**BCA REPORT**  
*Preliminary Review*

**GOULBURN PERFORMING ARTS CENTRE**

Revision: 0  
Date: 12 August 2016  
Project No.: 160301

This report comprises a review of the Schematic Design documentation for the proposed Goulburn Performing Arts Centre against the NCC Building Code of Australia 2016 (BCA)

Figure 2: Option showing non-EV Part fire separated from EV

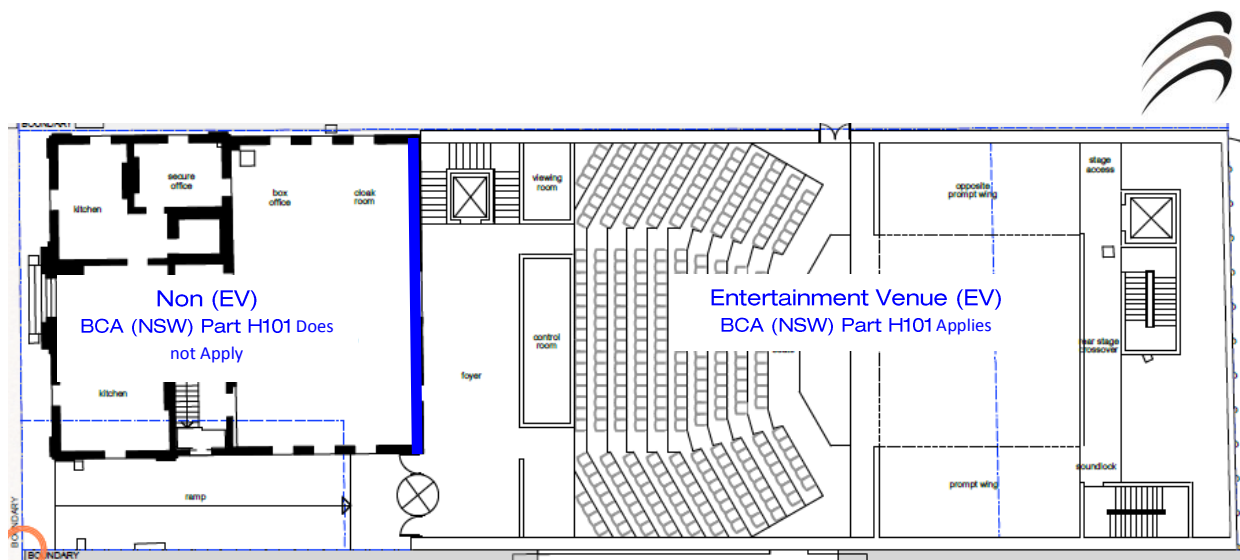
The above provisions will need to be applied to the whole building; however where areas such as the the existing building part are fire separated from the remainder of the building by construction achieving 60/60/60 FRL, then provisions of BCA (NSW) Part H101 need not be applied to the non-EV fire separated part. An example is provided below in Figure 2.

Figure 2a: Location of Fire Walls

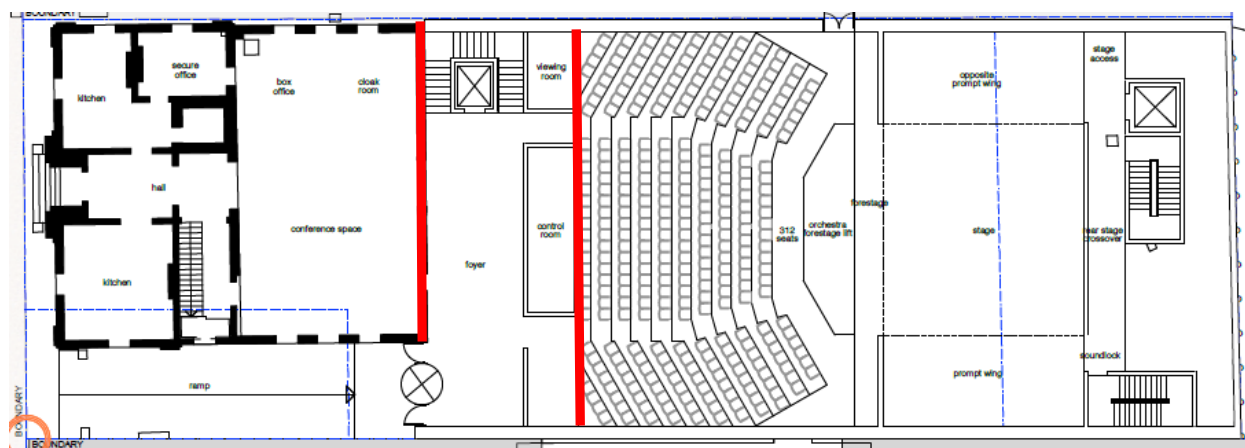
4. Having regard to fire compartmentation within the building, we note that 2hr fire walls will be required between the existing and new building parts and between the auditorium and the lobby, as indicated below:

There may be opportunity to reduce the FRL of the fire walls located between the existing and new building parts subject to a fire engineered Alternative Solution based upon the installation of the sprinkler system.

Figure 3: Boundary locations

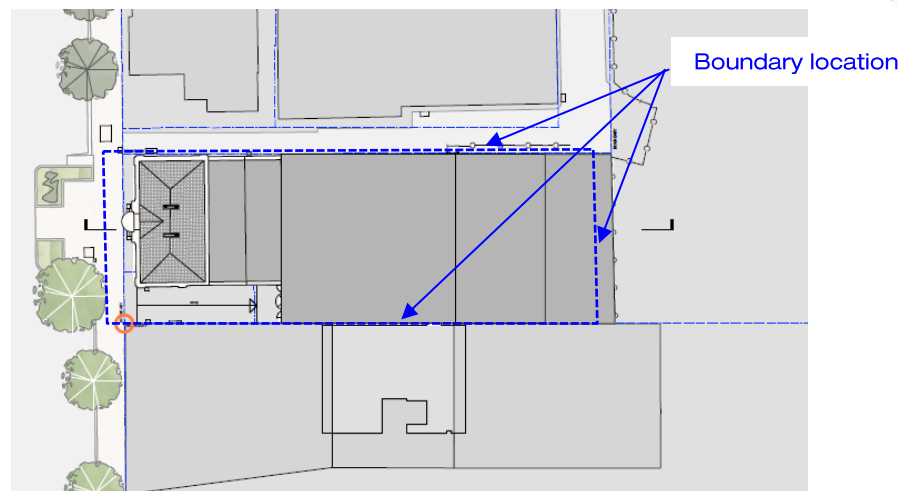
10. Based upon the site plan, it appears that the existing and proposed parts of the building are located directly adjacent to the site boundaries, being the Fire Source Feature. As such the external walls will typically need to be fire rated to achieve not less than 2hrs, whilst any openings located within the elevations that are less than 3m from the subject boundary line will need to be protected.

Further verification will need to be provided having regard to the building setback from the site boundaries along with verification of the parcel of land located to the North East of the site and whether rights to this land is permitted via easements or the like.

Figure 4: Single exit non compliance - Mezzanine

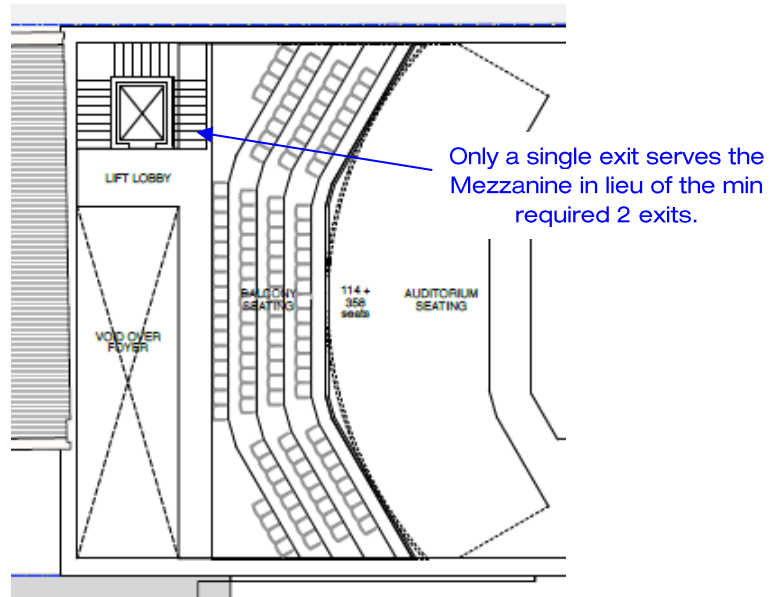
1. In a Class 9b building that can accommodate more than 50 persons, must be provided with not less than 2 exits. In this regard, we note that there appears to be only a single exit serving the Mezzanine level, in lieu of the minimum required 2.

Please note that there may be opportunity to provide an Alternative solution for the single exit to the mezzanine, providing the egress width accommodates the population (approx. 3m wide), sprinklers installed and smoke exhaust is provided above this area.

Figure 5: Single exit non compliance – Basement Level

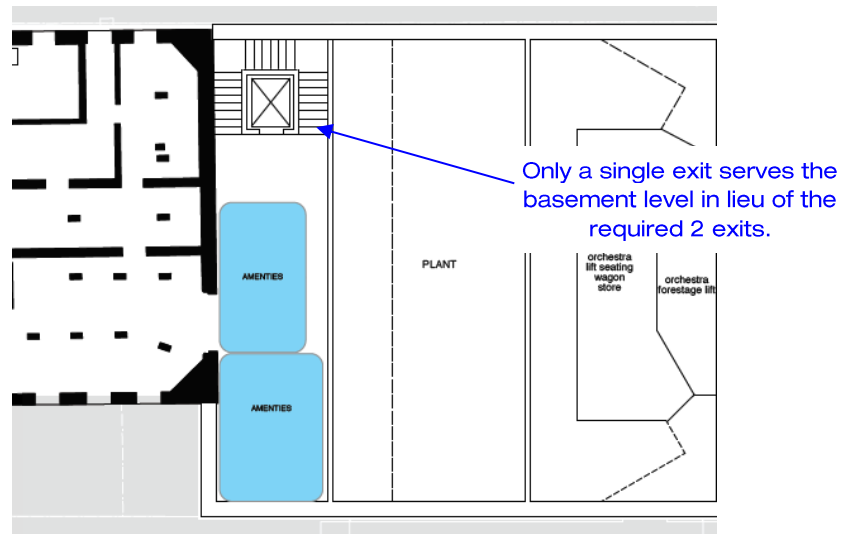
In addition to the above, we note that where travel from a storey involves the vertical rise within the building of more than 1.5m, where the floor area is greater than 50m<sup>2</sup>, then two exits must be provided. In this regard we note that travel from the basement level amenities is served by a single exit rather than the minimum required 2 exits.
